ADMINISTRATIVE SUBDIVISION PLAN

Lot 4, Block 2 of Longwood

7025 Longwood Drive

RE: Administrative Plan No.  
120190100  
Longwood

**FIRE DEPARTMENT APPARATUS ACCESS PLAN**  
**Lot 4, Block 2 of Longwood**  
**7025 Longwood Drive**  
**Montgomery County, Maryland**

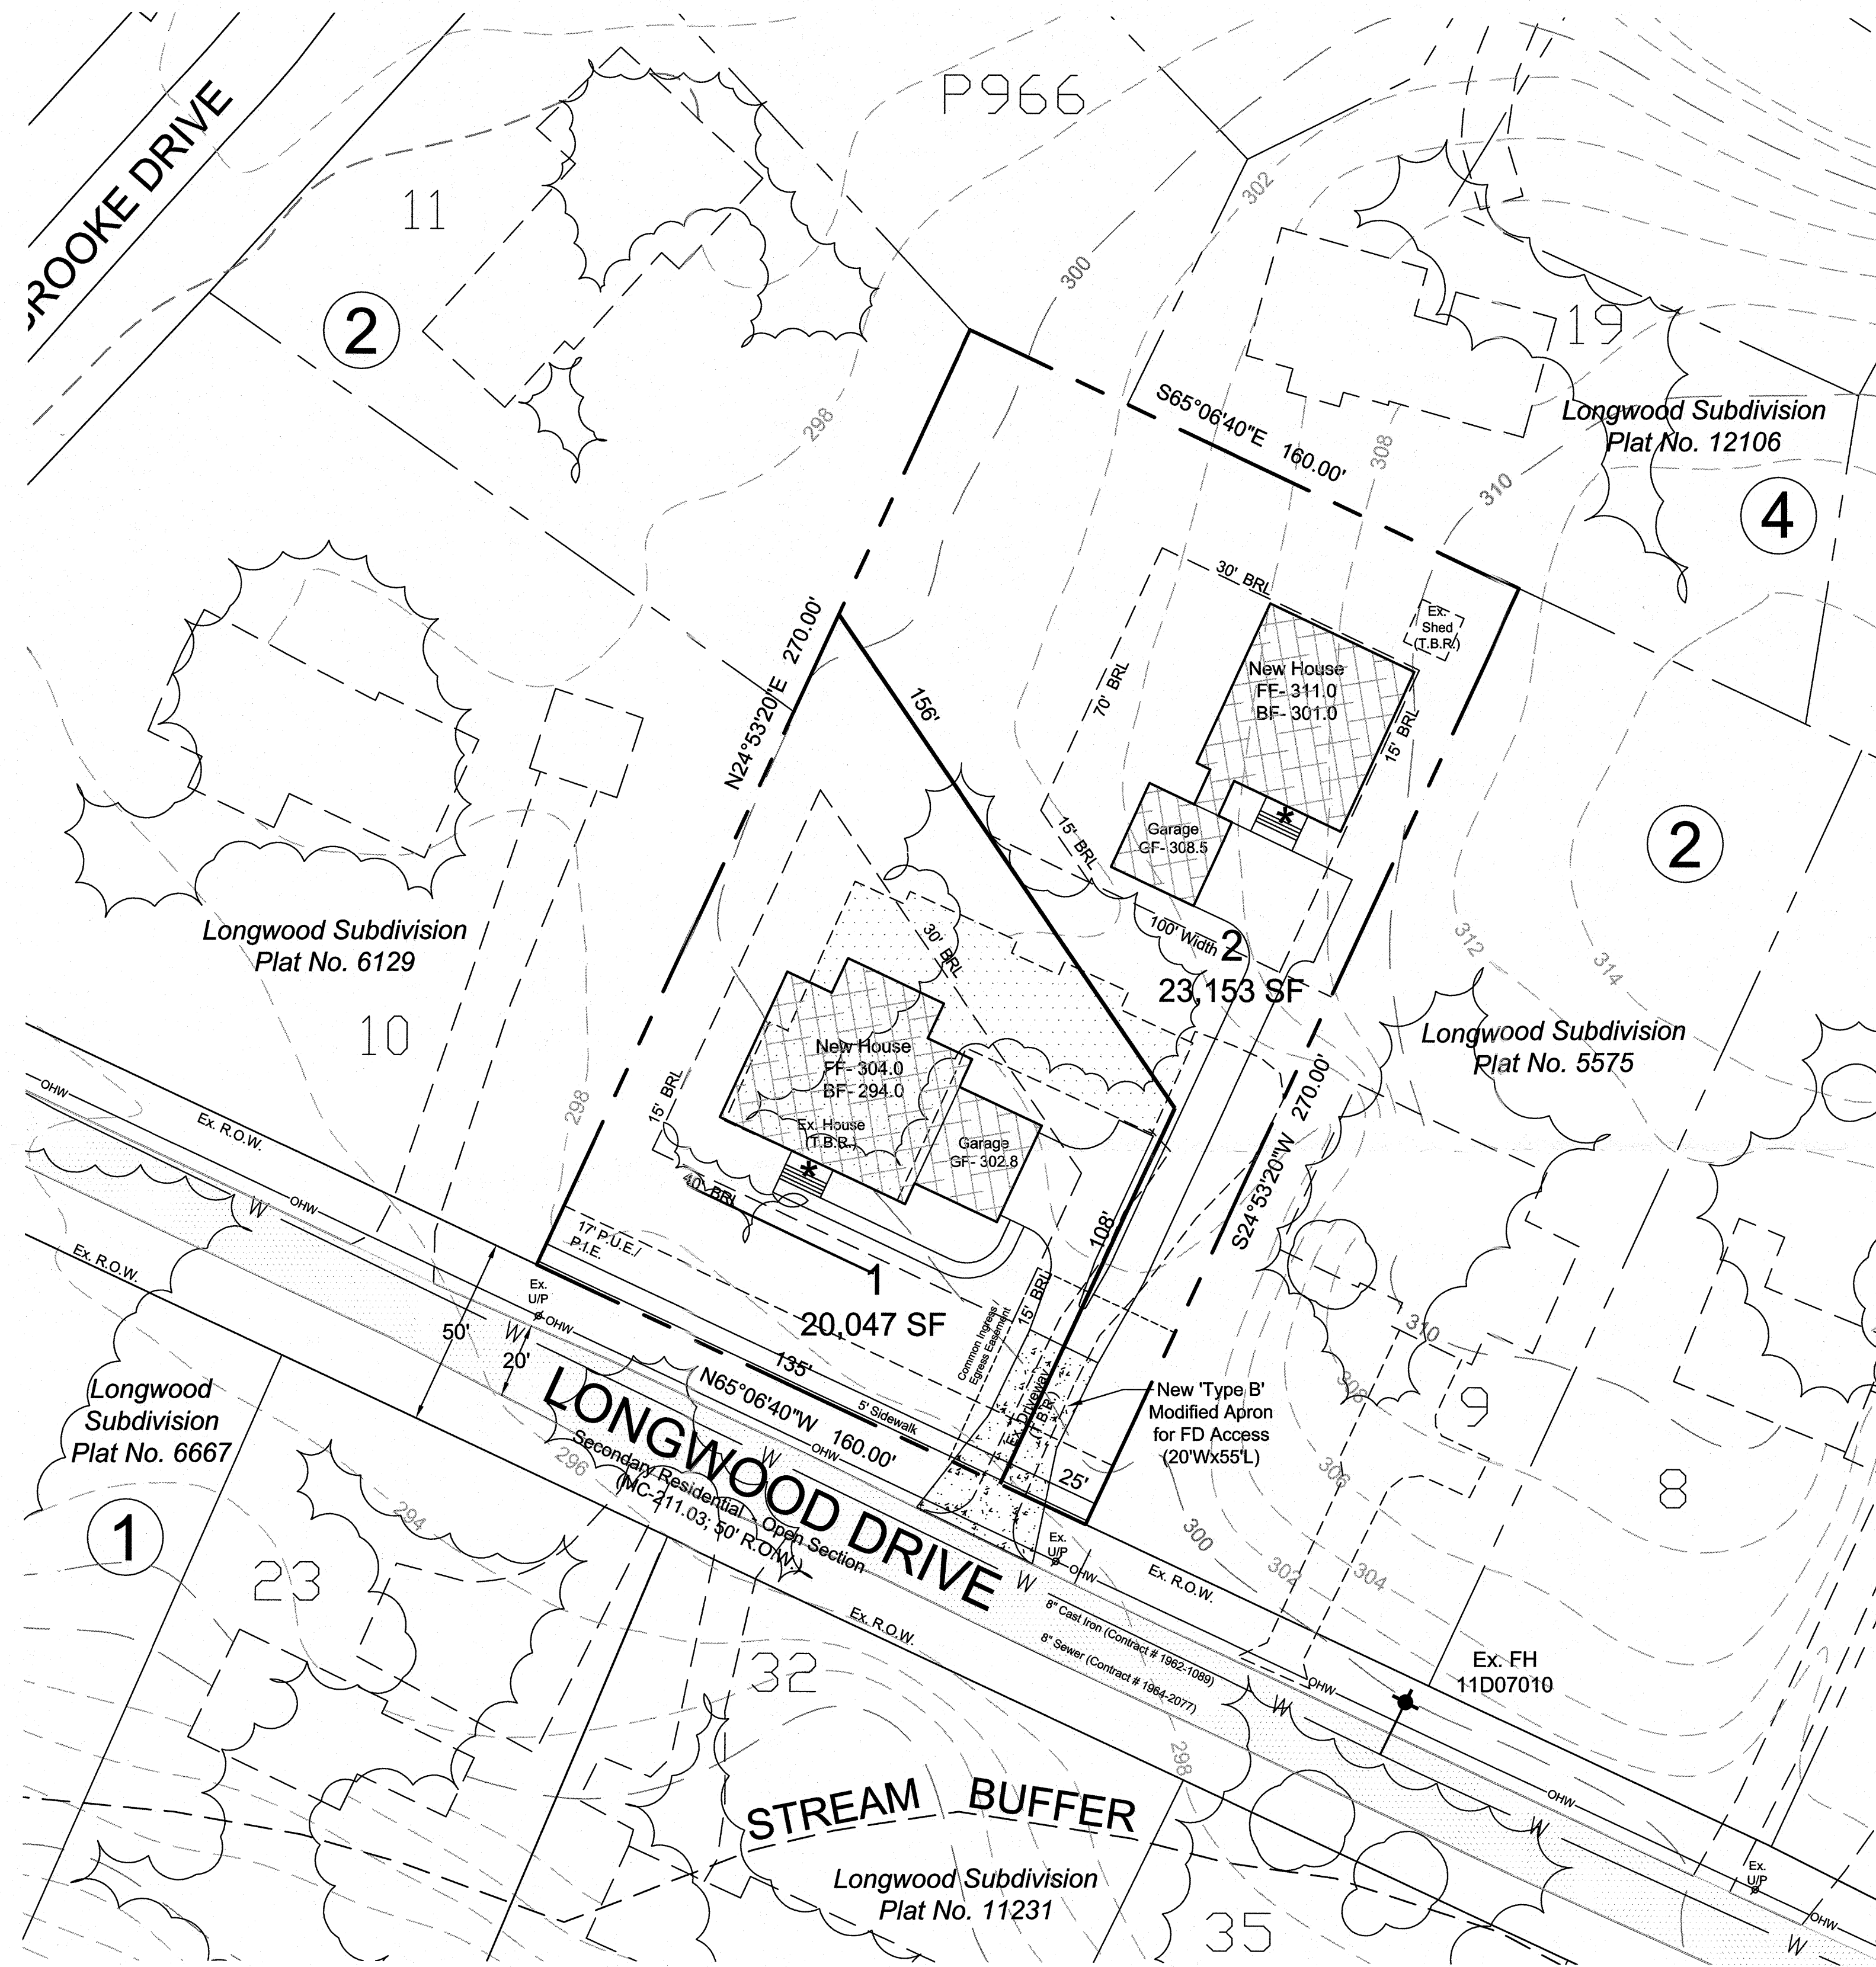
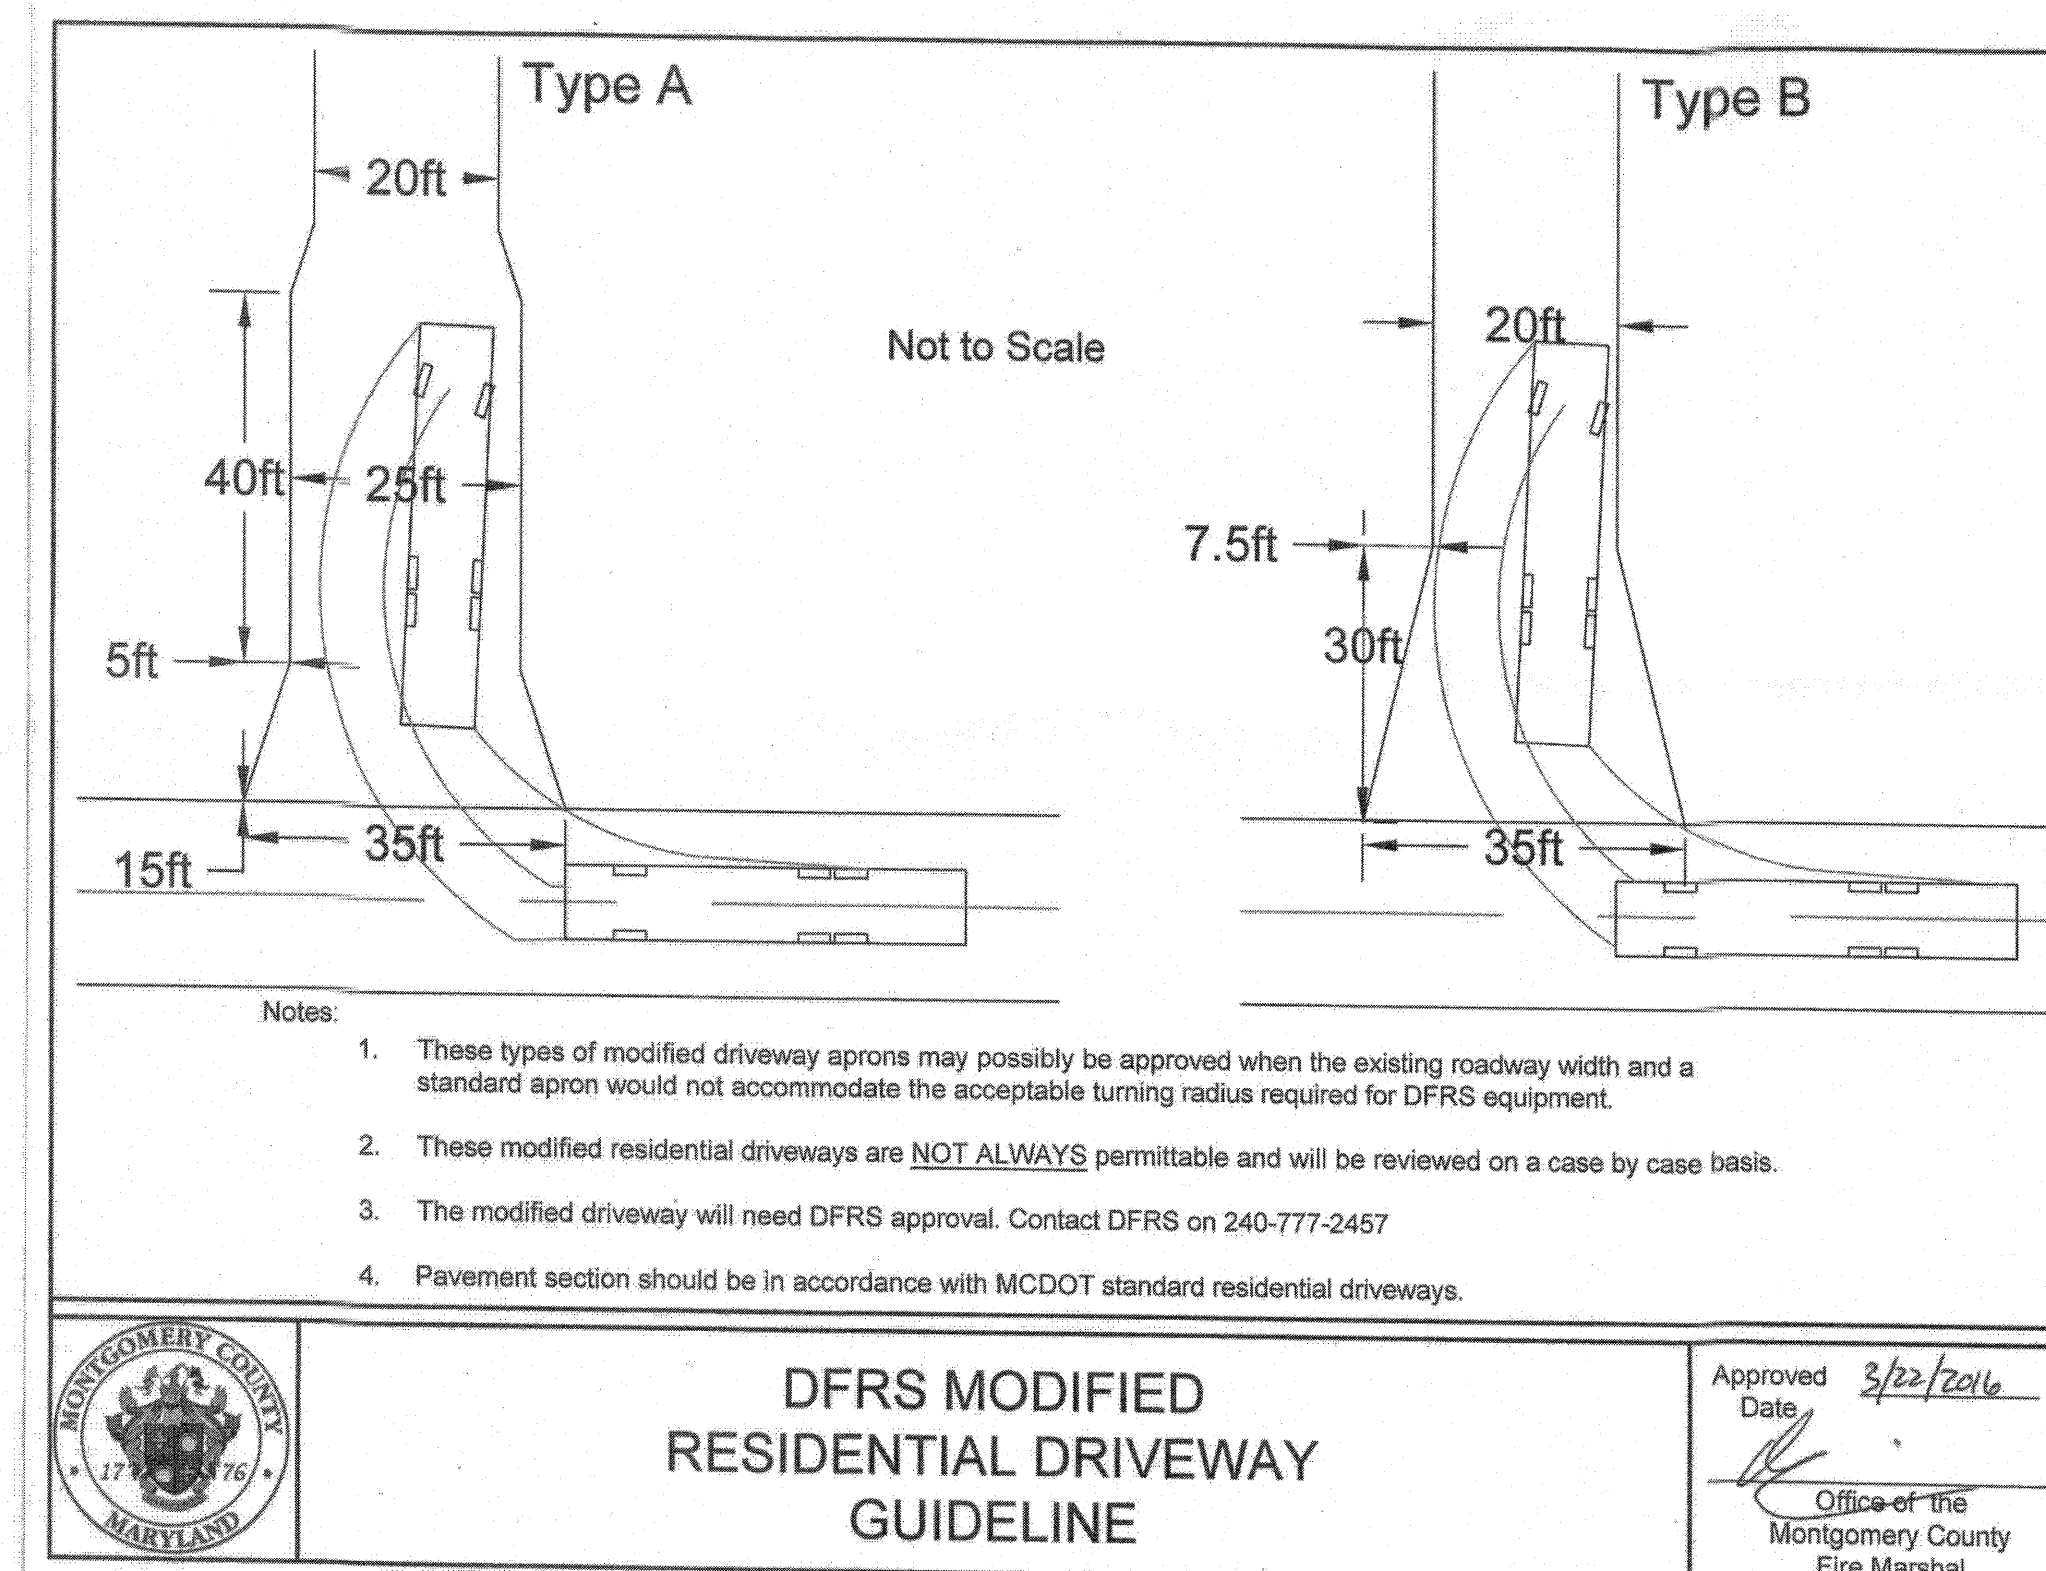
**PLAN APPROVED**

1. Review based only upon information contained on the plan submitted **19-Nov-19**. Review and approval does not cover unsatisfactory installation resulting from errors, omissions, or failure to clearly indicate conditions on this plan.
2. Correction of unsatisfactory installation will be required upon inspection and service of notice of violation to a party responsible for the property.
